From: Howard Carter <hc@thinkingspace.co.uk>
Sent: 08 February 2012 15:51
To: Hannah Barker
Cc: Sergio Falletti
Subject: Re: 12 Falcon Close Shoreham-By-Sea AWDM/1063/11
Attachments: 1105_SK01.pdf; 1105_SK02a.pdf; 1105_SK03.pdf; 1105_SK04.pdf; 1105_SK05.pdf; 1105_SK06.pdf; 1105_SK07_a.pdf; 1105_SK08_a.pdf; 1105_SK09_b.pdf; 1105_SK10_b.pdf; 1105_SK12_b.pdf

Nº 12 Falcon Close, Shoreham by Sea, Sussex, BN43 5HN
Site area ; 1,072 sqm

Falletti House
12 Falcon Close, Shoreham by Sea

2 proposed - Falcon Close elevation
1:100

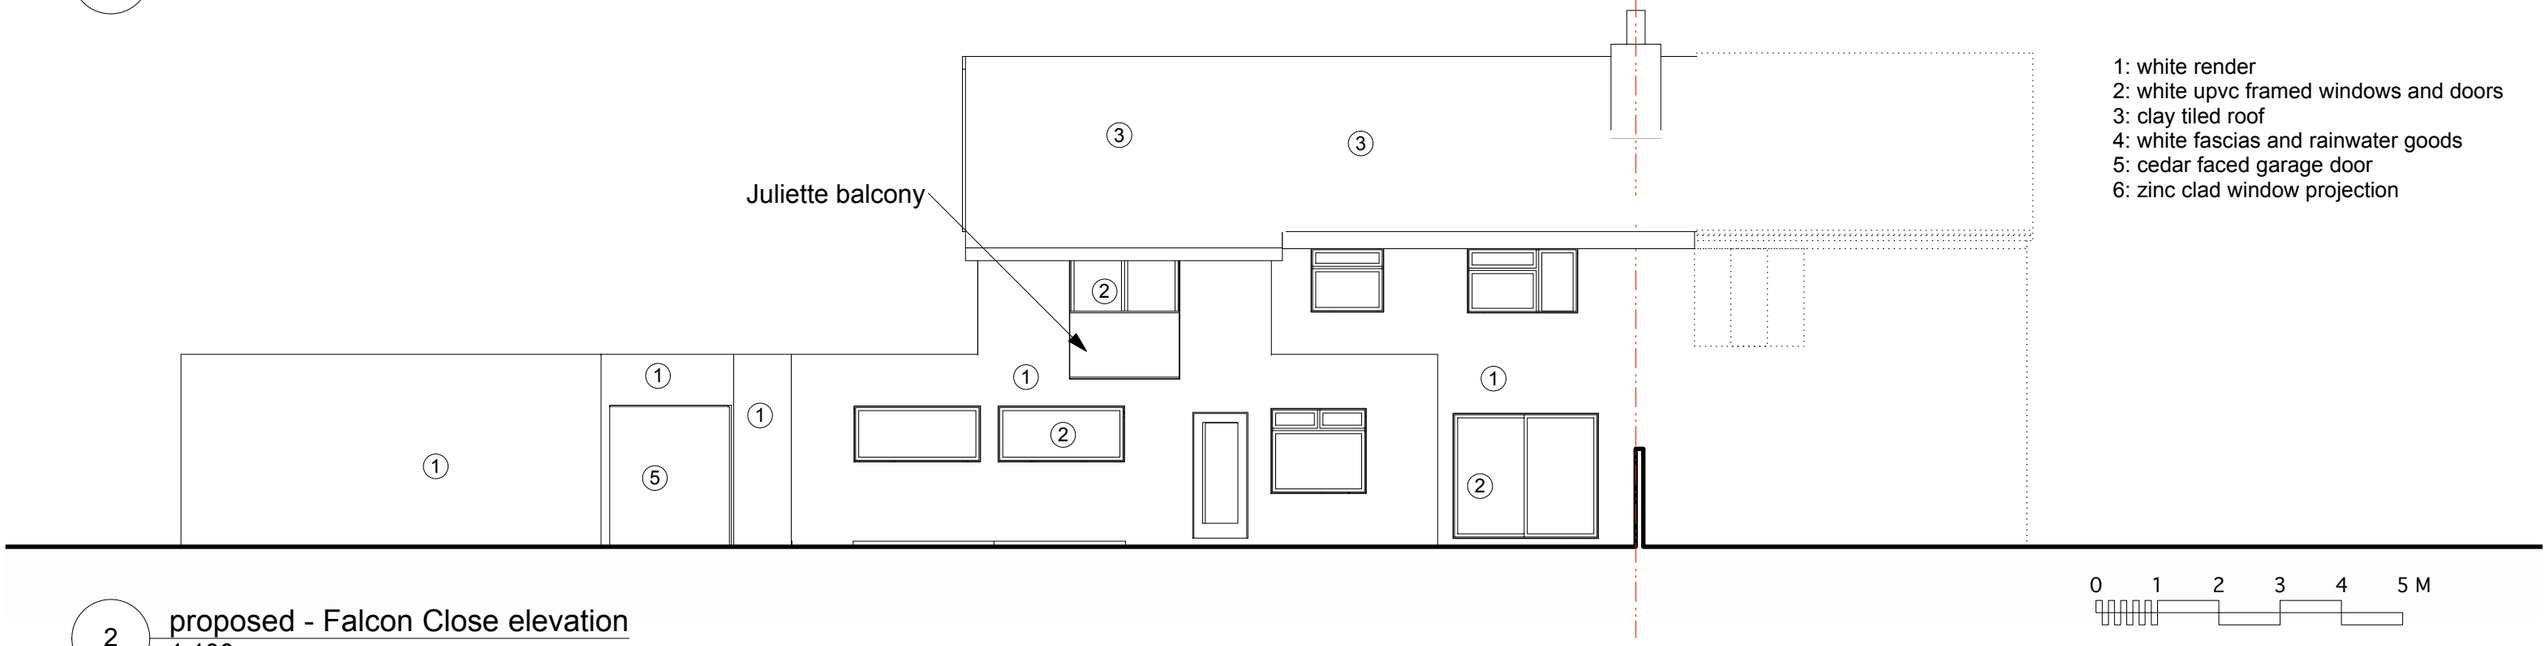
The revised design is much better with gable roof and removal of the window projection. The ridge however should not be higher than the existing ridge height. The extension should be subservient to the main dwelling house. Therefore the ridge should be set down and extension set back slightly. It should be flush with the front of the house or have nominal set back to allow the ridge to drop. I note that the ensuite and bedroom one are of a generous size so could accommodate this reduction in depth.

Dear Hannah, I have discussed this with my client and amended the plans to show a consistent ridge line.
We cannot however agree to setting back the extension facade. This sort of subtle differentiation at the end of terraces is a well established design motif from traditional and modern design and is considered good urban design. I attach some images that illustrate this on a slightly grander scale. There are also compelling design and structural reasons why setting back the extension is undesirable.

2 proposed - north elevation
1:100

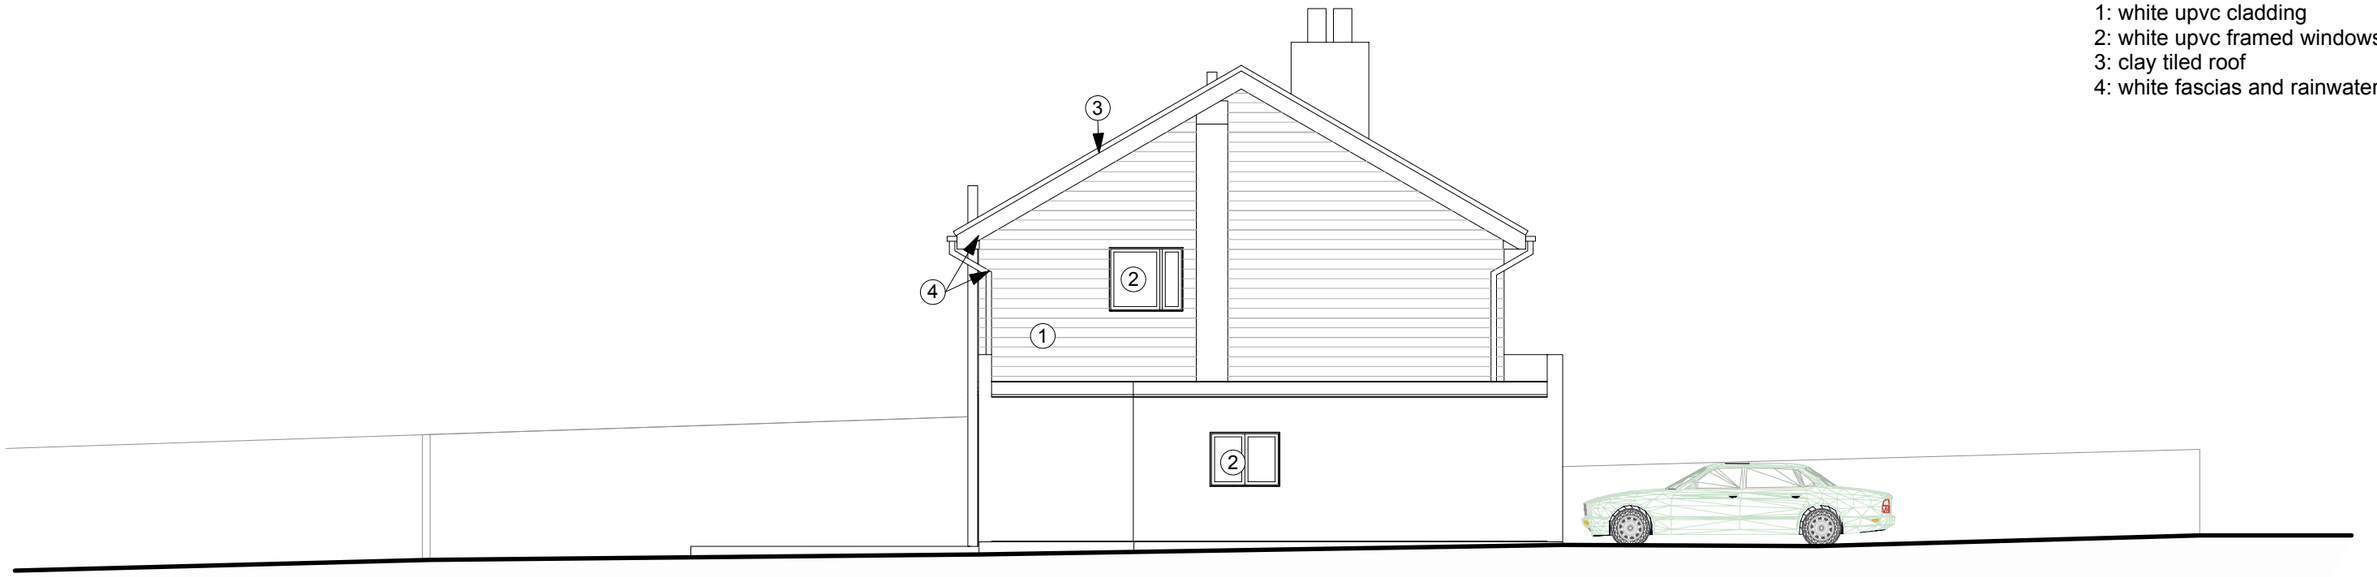
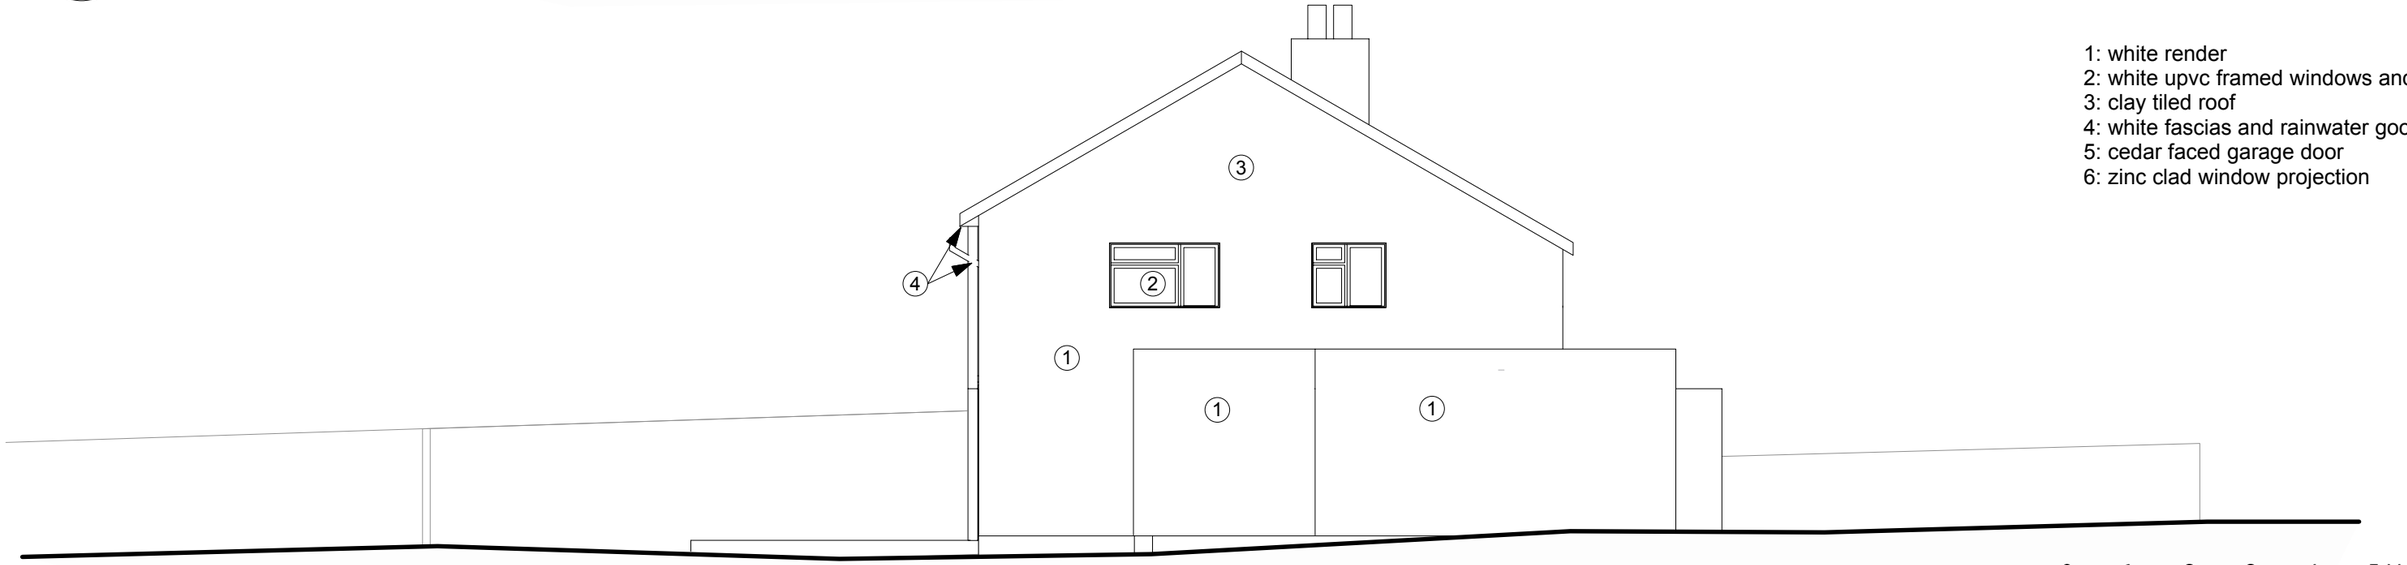
This states that the extension should usually be set back slightly from the main front wall of the dwelling to create a visual break and ensure the extension is subordinate to the main dwelling.
